Well information: **30-039-06009 JICARILLA APACHE F #004**

**Plug and Abandonment Procedure**

**Jicarilla Apache F 4**

**API # 30-039-06009**

# DJR Operating, LLC Proposed Wellbore Diagram

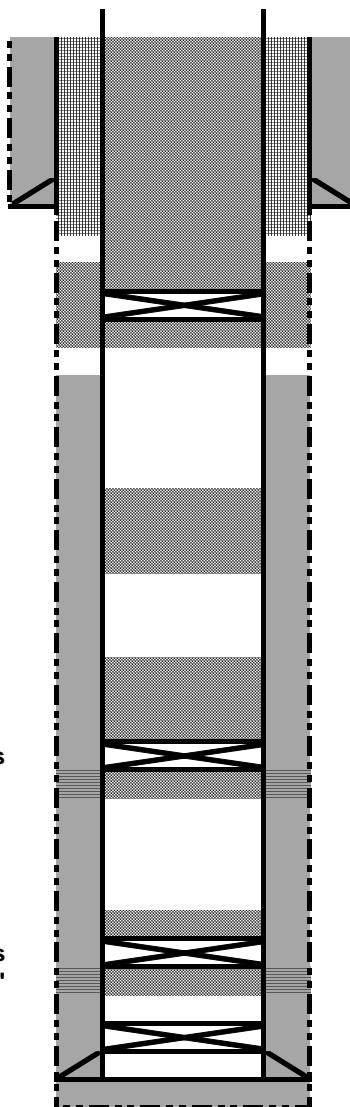
- Notify NMOCD 24 Hours prior to commencing activities
- CBL Required
- In addition to the BLM approved plugs, add the following: Plug from 2524'-2424' OCD and BLM Fruitland pick @ 2474'. Plug from 2235'-2135'. OCD and BLM Kirtland pick @ 2185'.

1. Plugging operations authorized are subject to the attached "General Requirements for Permanent Abandonment of Wells on Federal and Indian Lease."
2. Farmington Office is to be notified at least 24 hours before the plugging operations commence (505) 564-7750.
3. Submit electronic copy of the CBL for verification to the following addresses: [jkillins@blm.gov](mailto:jkillins@blm.gov) and [Brandon.Powell@state.nm.us](mailto:Brandon.Powell@state.nm.us) . Based on CBL results inside/outside plugs and volumes will be adjusted accordingly. Please review the General Requirements document to ensure volumes meet required excess inside and outside casing.
4. Add a plug or modify plug 4 to place a inside/outside of production casing a cement plug to extend at least 50 feet below bottom of and 50 feet above the surface casing shoe at 224.

- Log analysis of reference well #2 indicates the Nacimiento and Ojo Alamo sands investigated likely contain fresh water ( $\leq 5,000$  ppm TDS). The proposed P&A plan has adequate plugs to ensure fresh water sands are protected in this well bore.
- Chacra perforations @ 3477'-3610'.
- Pictured Cliffs perforations @ 2608'-2658'.

OCD Reviewer	Condition
ahvermersch	Notify NMOCD 24 Hours prior to commencing activities • CBL Required • In addition to the BLM approved plugs, add the following: Plug from 2524'-2424' OCD and BLM Fruitland pick @ 2474'. Plug from 2235'-2135'. OCD and BLM Kirtland pick @ 2185
